BINASLAWA MIDDLE SCHOOL

SIGIR PA-08-121

SUBJECT: Report on Project Assessment of the Binaslawwa Middle School, Erbil, Iraq (Report Number SIGIR PA-08-121)

Figure 1. Cesspool block structure with weakened offset blocks

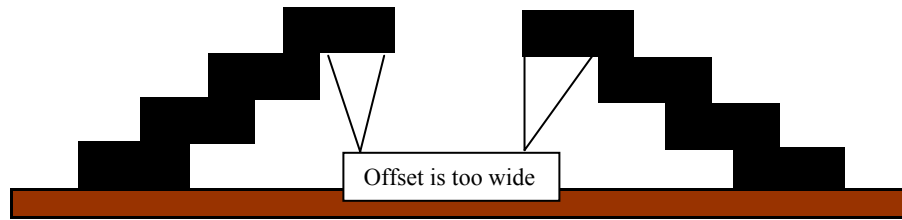
- The cesspool access-door structure showed inferior workmanship and was susceptible to collapse.
3. The contract did not require a quality control plan. However, adequate contractor management and government quality assurance oversight by the site supervisor appear to compensate for the missing quality control plan.

The septic tank and cesspool covers were made of cast iron attached to a concrete frame. The materials and workmanship were adequate. The concrete blocks used to construct the foundation for the access door to the cesspool were not properly offset which weakened the structure and making it vulnerable to collapse. The SIGIR engineer recommended that the construction needs to be redone and the contractor agreed. The weakened structure is depicted in Figure 1 below. Figure 2 illustrates an appropriate offset that would result in an acceptable structure. Site Photos 13 and 14 show the septic tank access covers and the cesspool cover.
